Project Title:	GYSBI SHORE BASE	Scale:	Scaled to fit	Date:	2024.03.27
Project Location:	Houston District, Greater Georgetown	Request/Surveyed by:	SLC Ops.Man. Maintenance		*****
Drawing Title:	VESSEL PLATFORM/STAIRS	Drawing by:	A.Flatts	Drawing #:	VPS-A-101
		Checked by:	I.Baksh B.Murli	Page No:	01
		Approved by:		Appr. Date:

Project Title:	GYSBI SHORE BASE
Project Location:	Houston District, Greater Georgetown
Drawing Title:	VESSEL PLATFORM/STAIRS

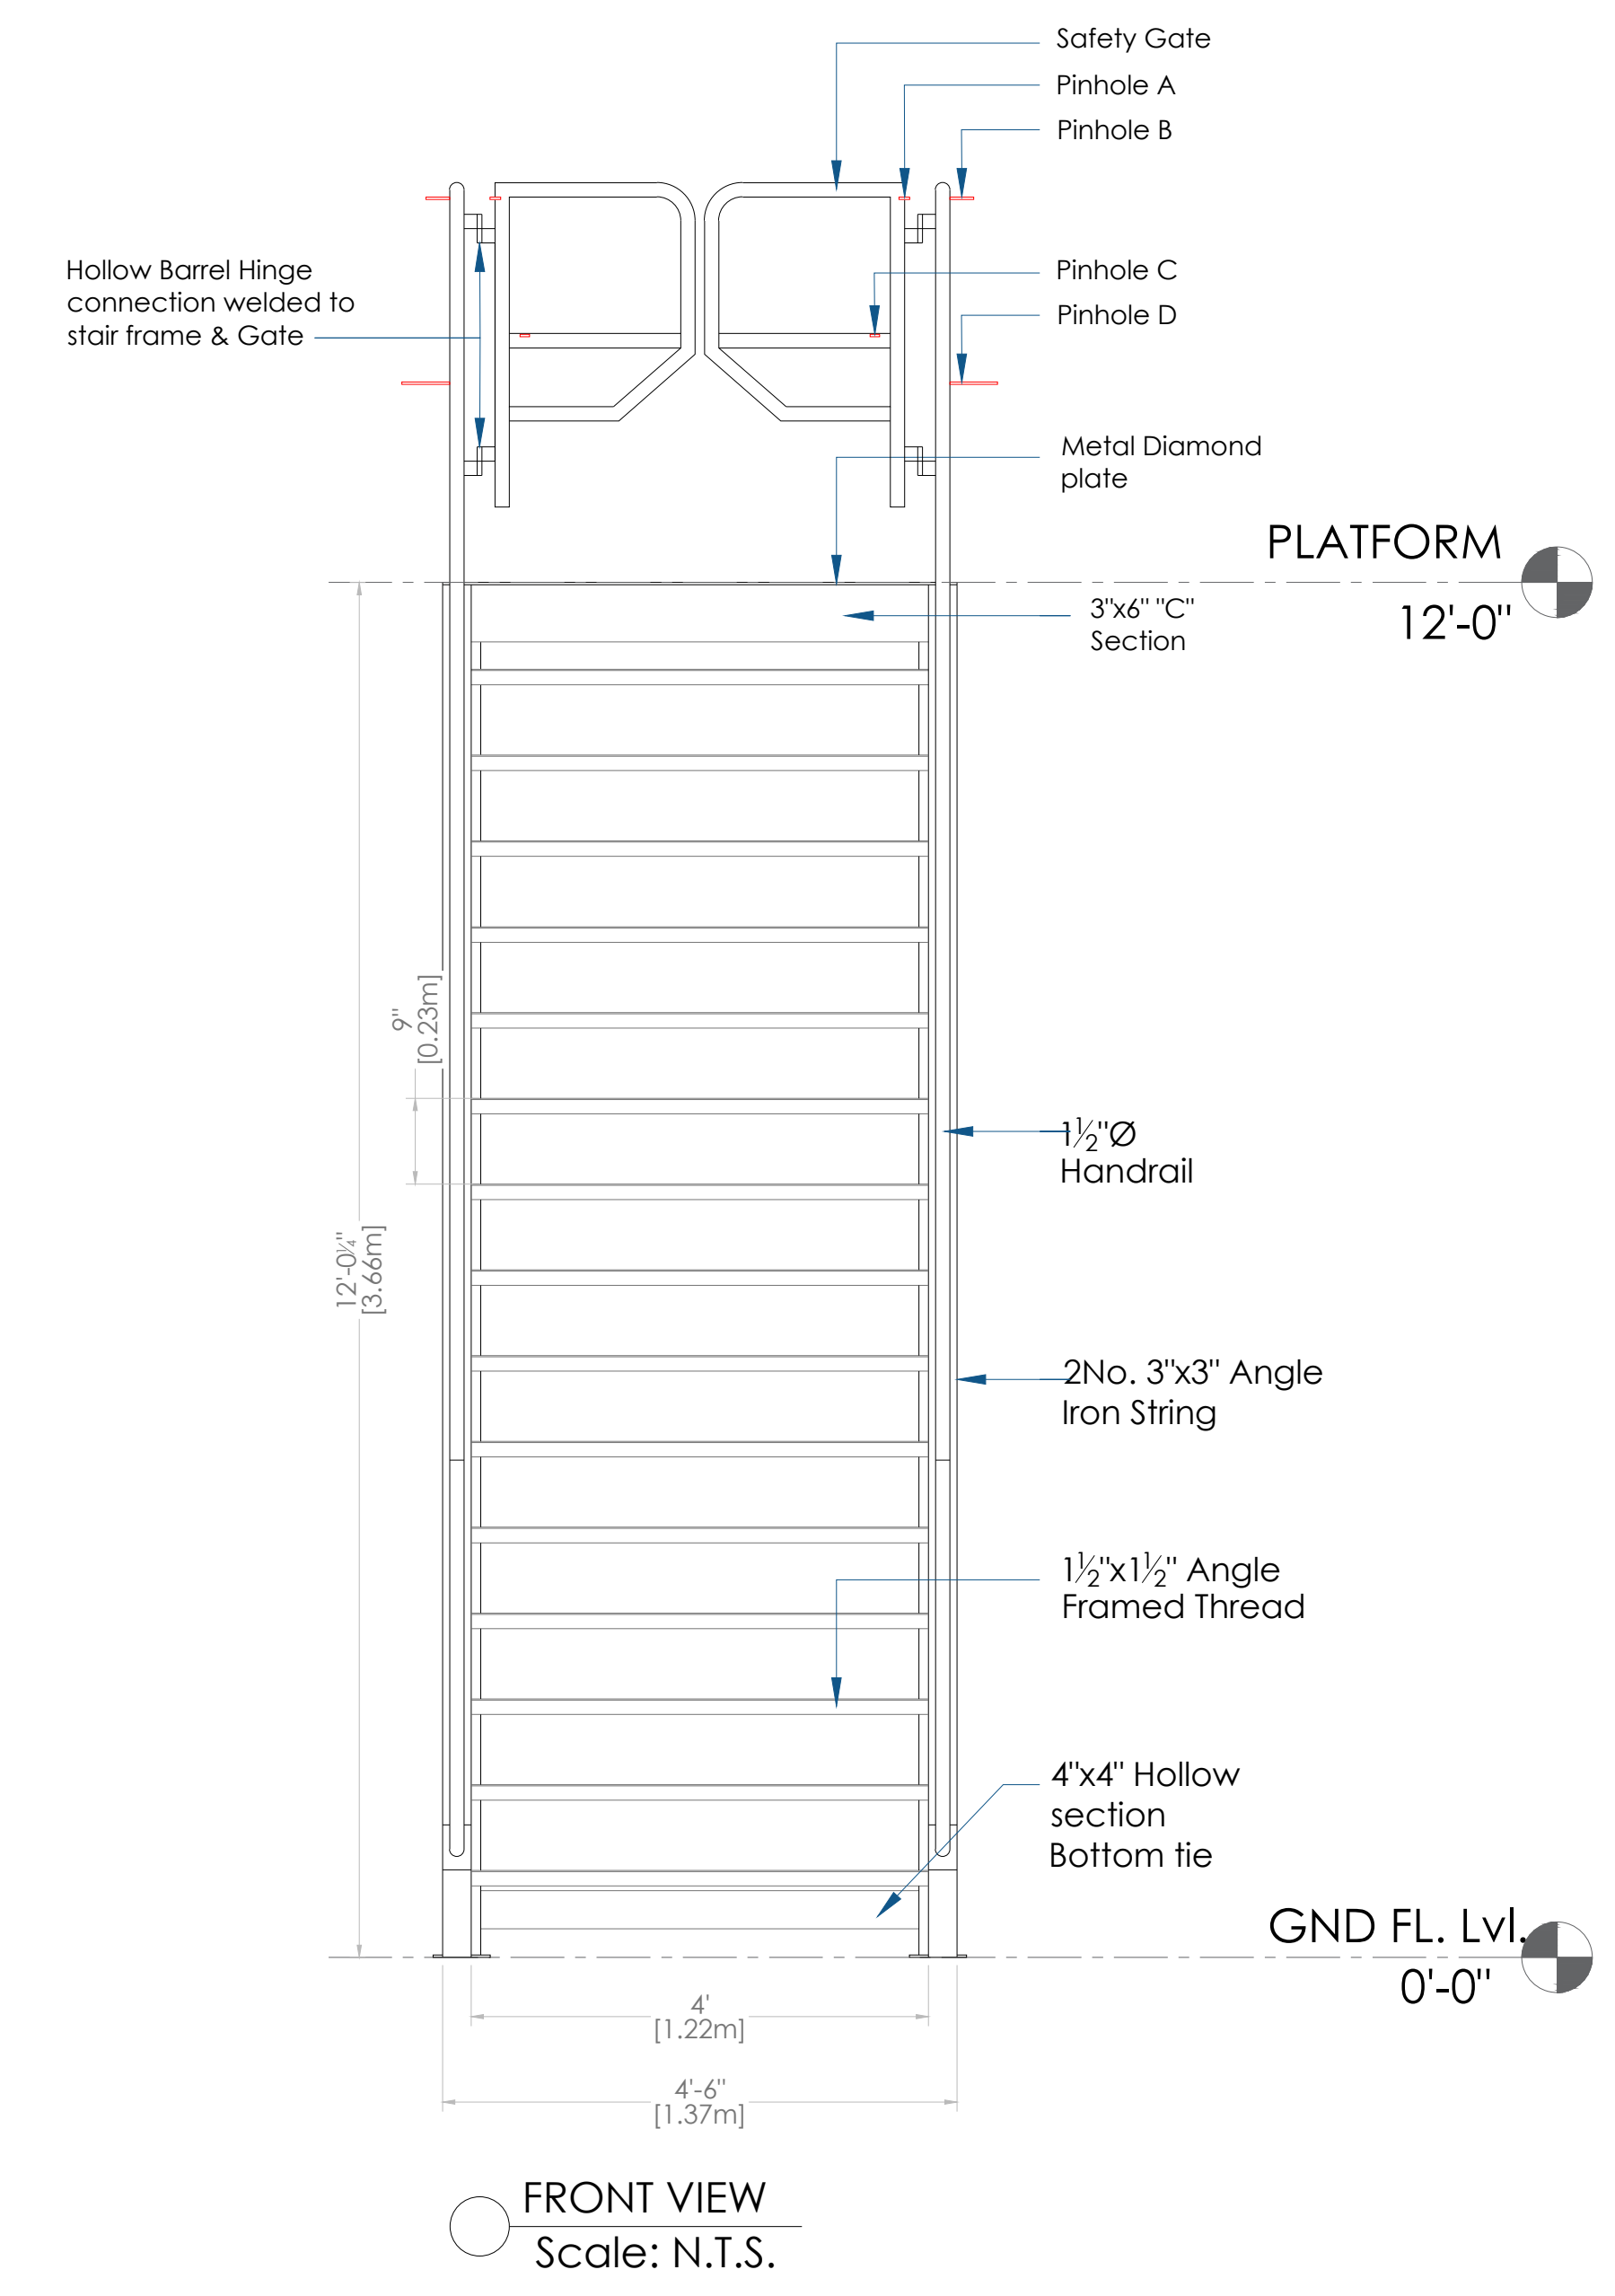
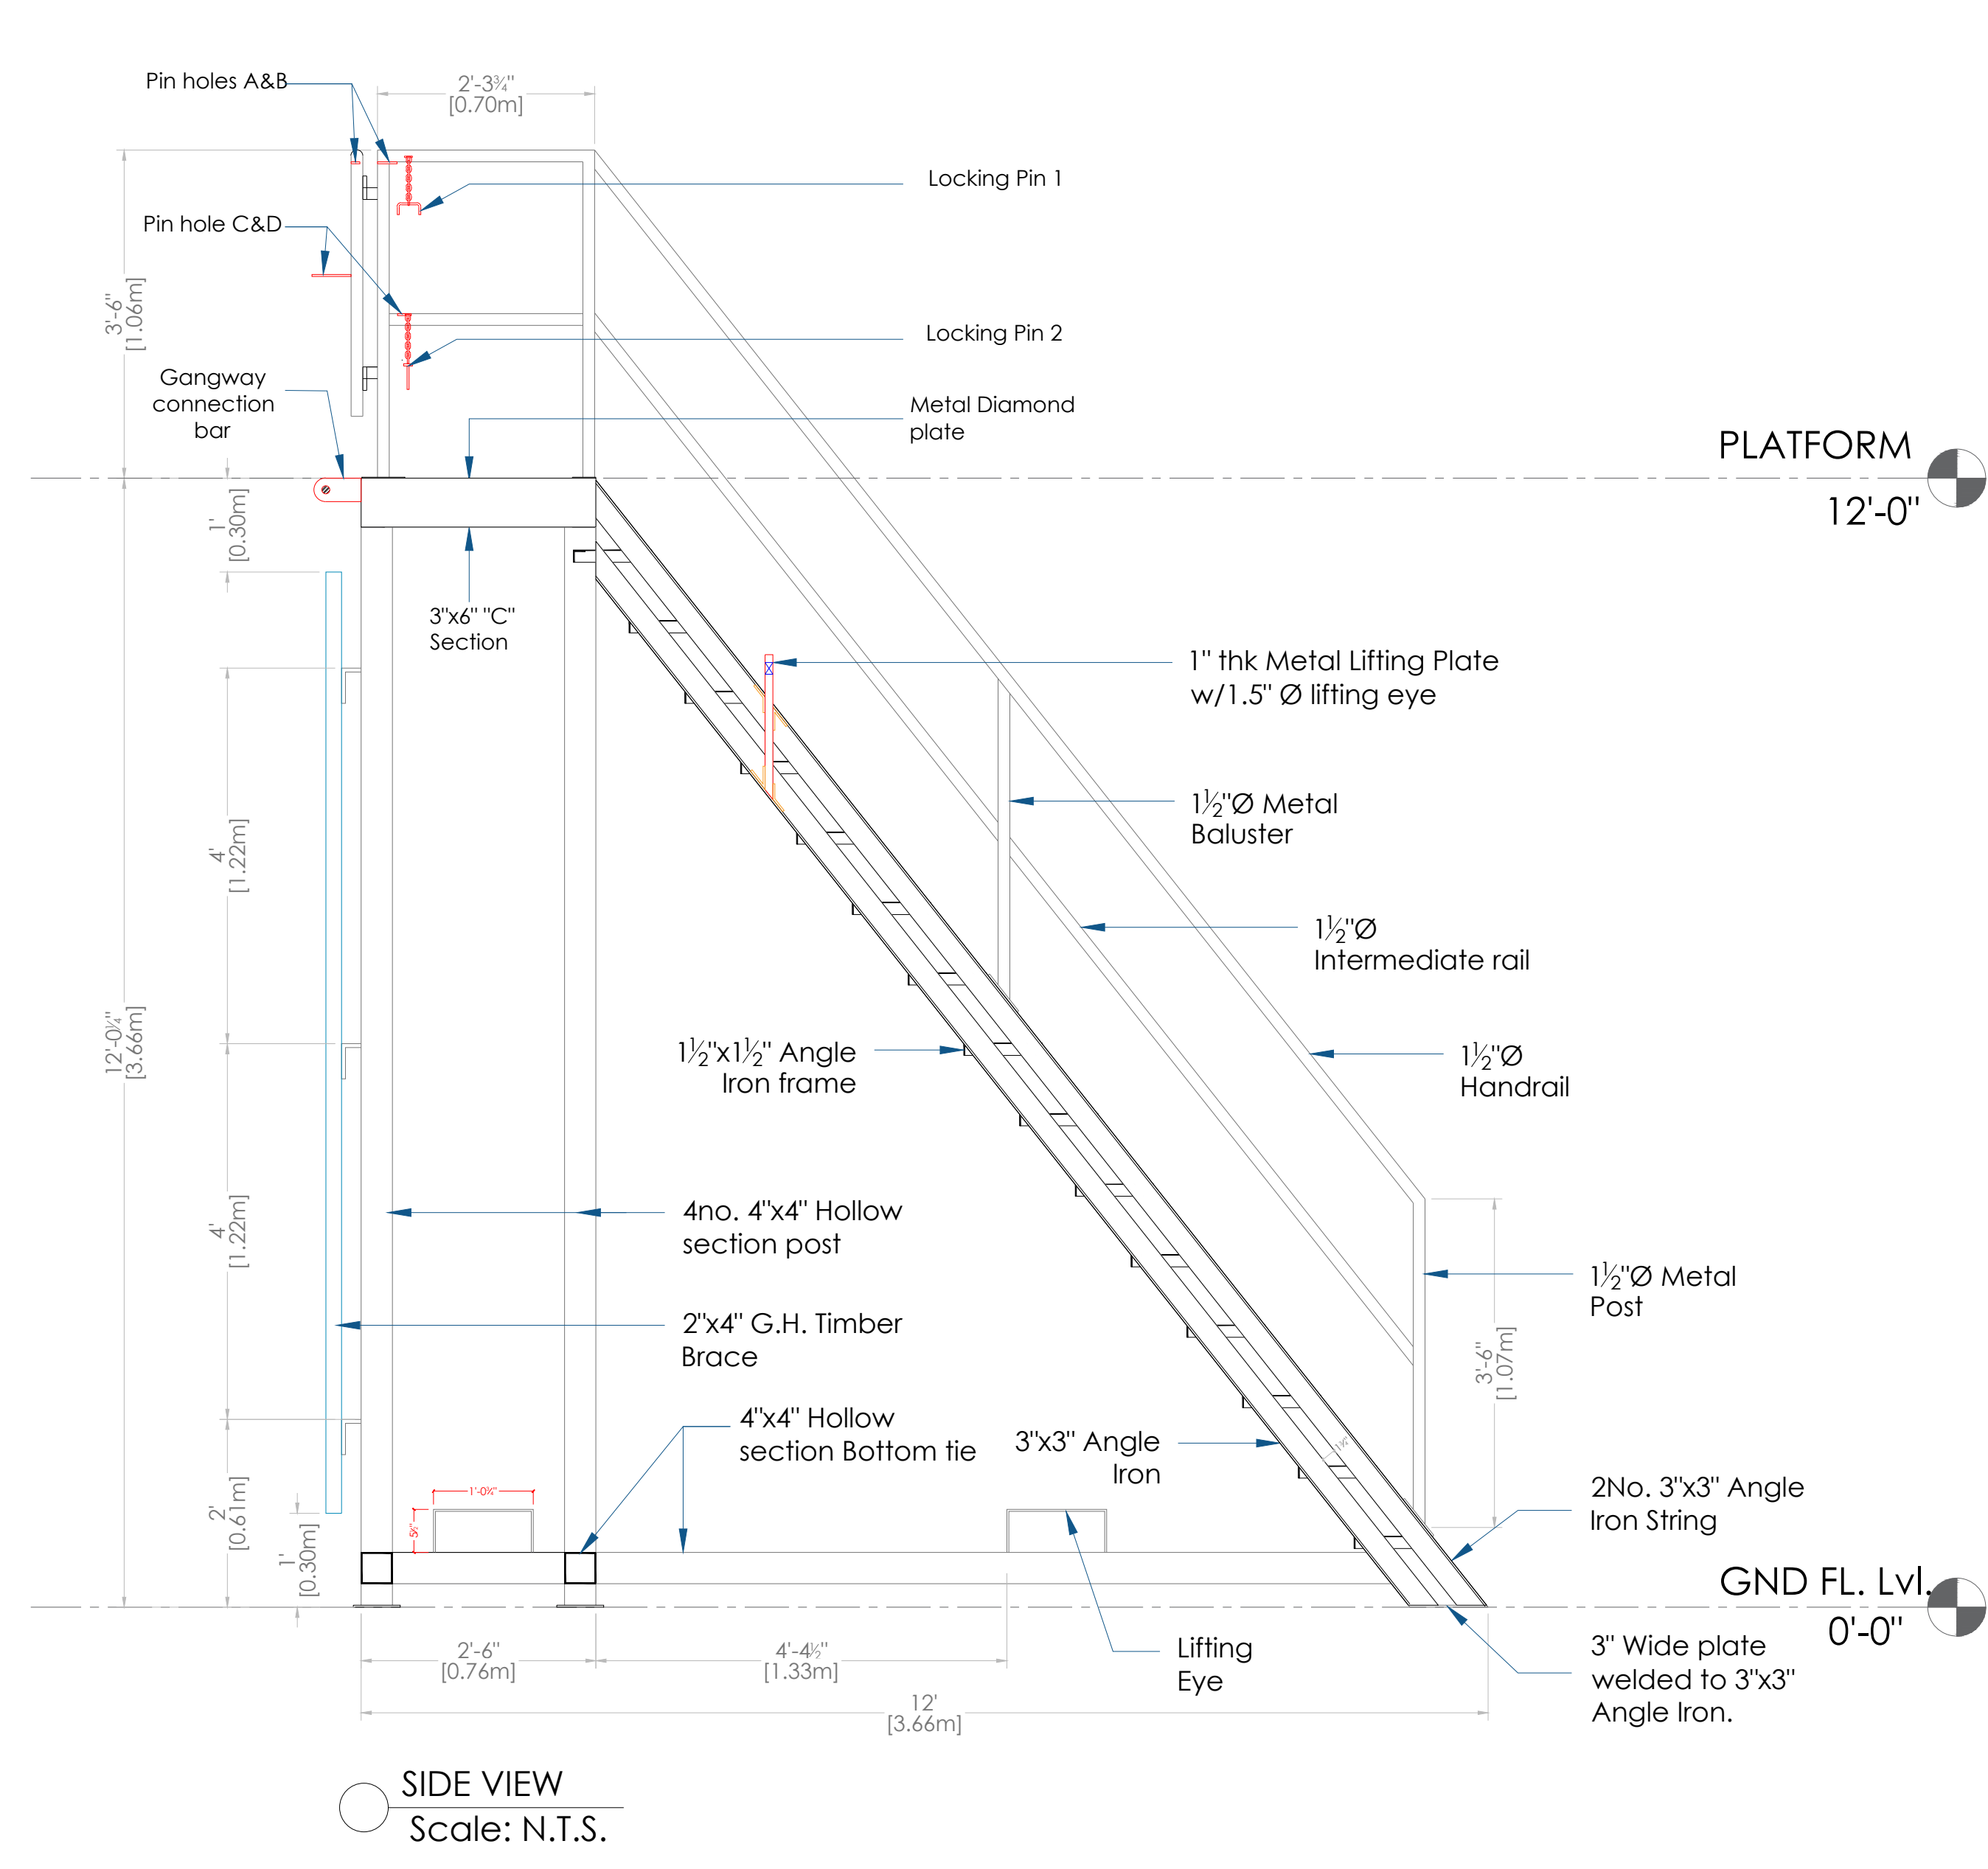
No.	REVISION	DATE	CLIENT
3	Stair lifting design update. 1" thk x 3" wide plate with 1.75" dia. lifting eye, welded to stringer frame and extended thru angled section about 5". Update reflects changes in "lifting eyes" on the stair stringer only. Other elements remain the same.	2024.03.26
